Marulan South Limestone Mine | SSD 7009

Water Management Plan

Prepared for Boral Cement Limited | 14th December 2023

Figure 3.1 Water quality monitoring sites

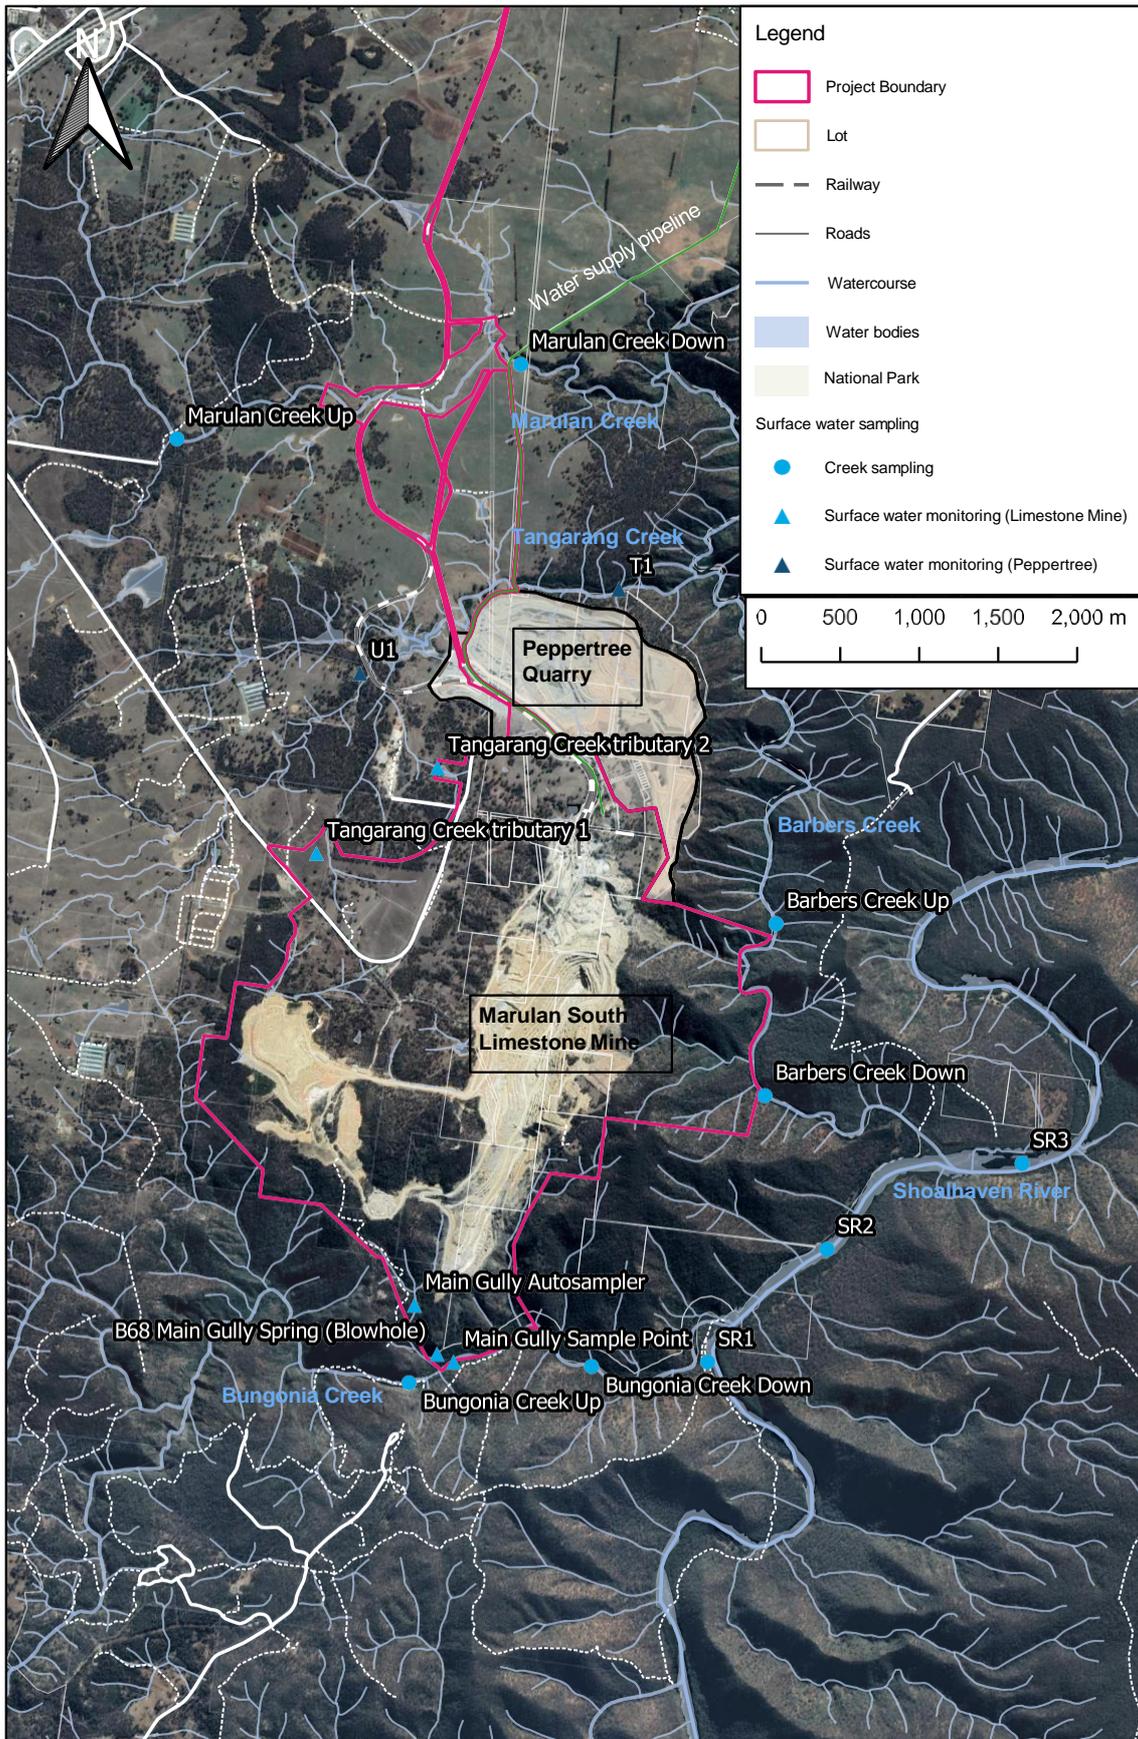
6.2.1	Section states that monitoring may cease in Barbers Creek and Shoalhaven River once NOE and WOE rehabilitation has been established. Monitoring should cease when the monitoring shows that those areas have stabilised	Adjusted sentence to include additional requirement.
	Table 6.2, 6.5 and 6.6	a reference to a map showing these locations should be included	Monitoring sites (Table 6.2) is shown in Figure 3.1. Dam and pipeline locations are shown in MSLM-WMP-ESCP-0005

Figure 5.2 Water treatment facilities

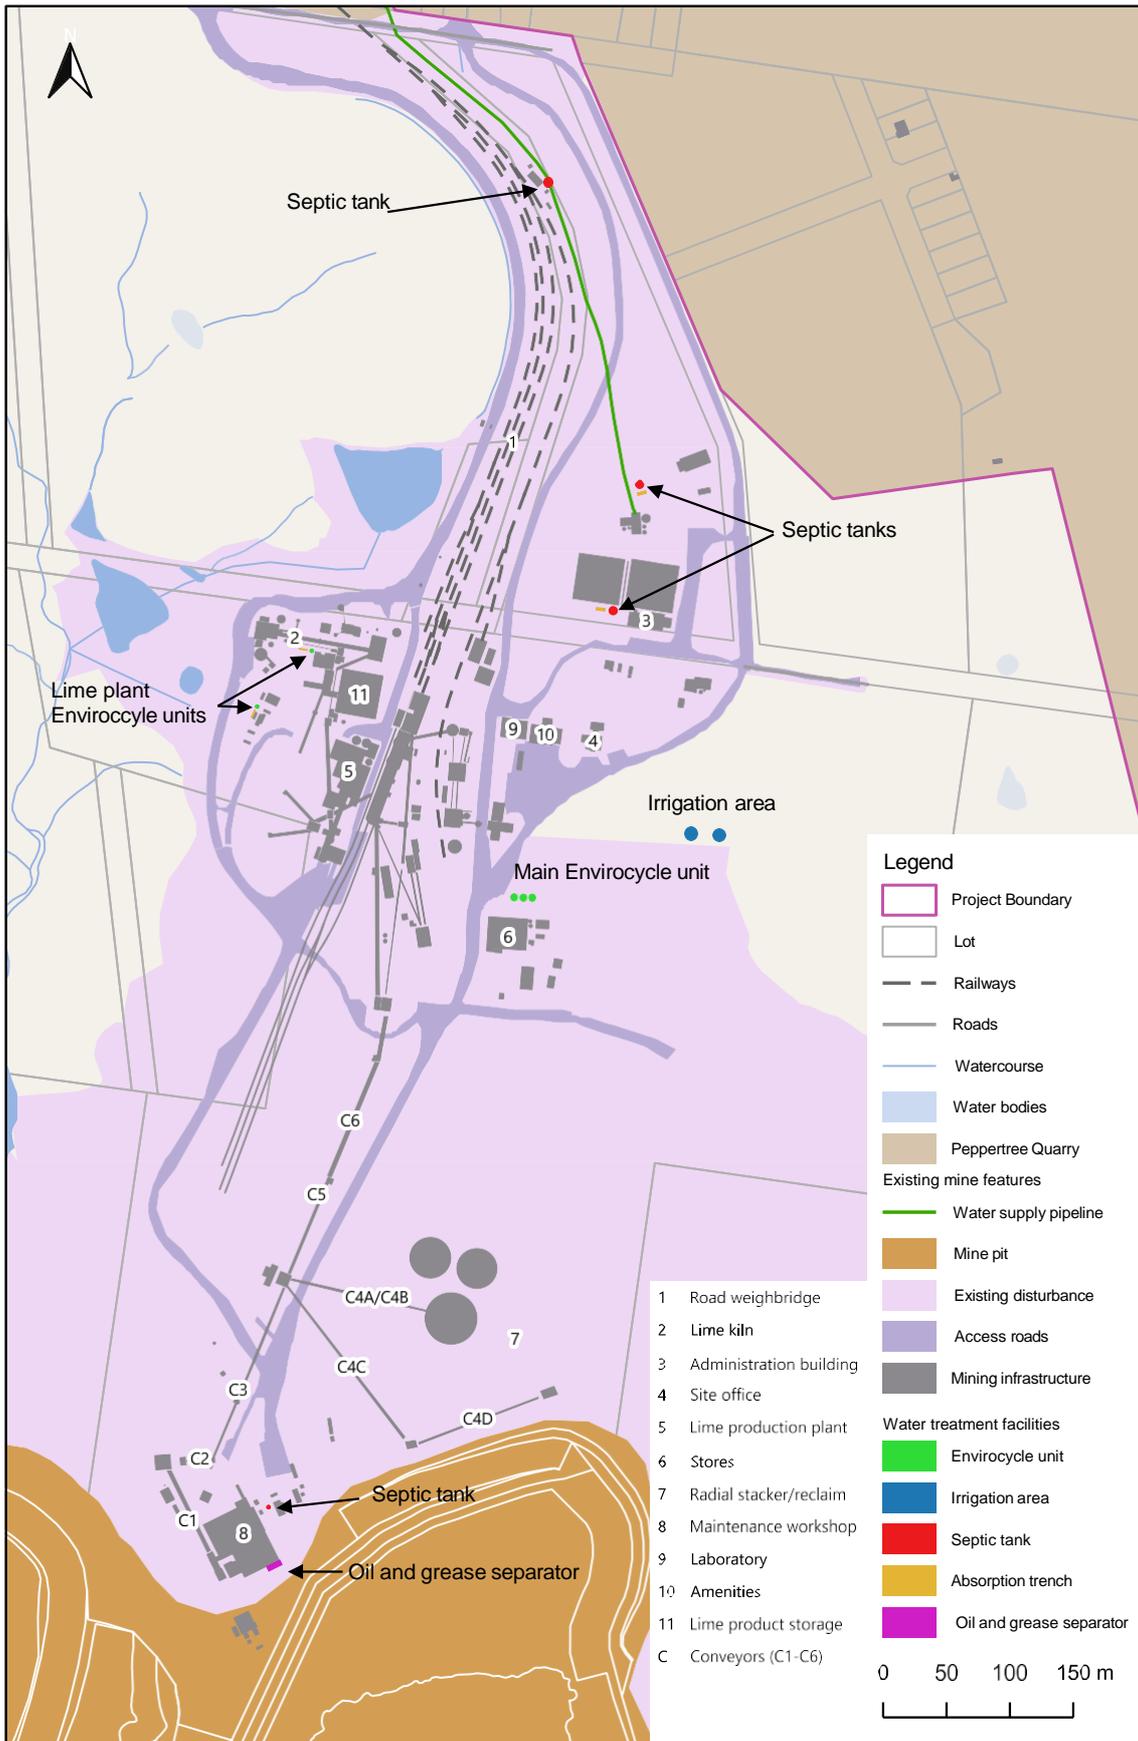
5.1.3	The location of all on-site wastewater systems, including the effluent management areas, should be shown on a plan of the site.	Additional figure (Figure 5.2) included
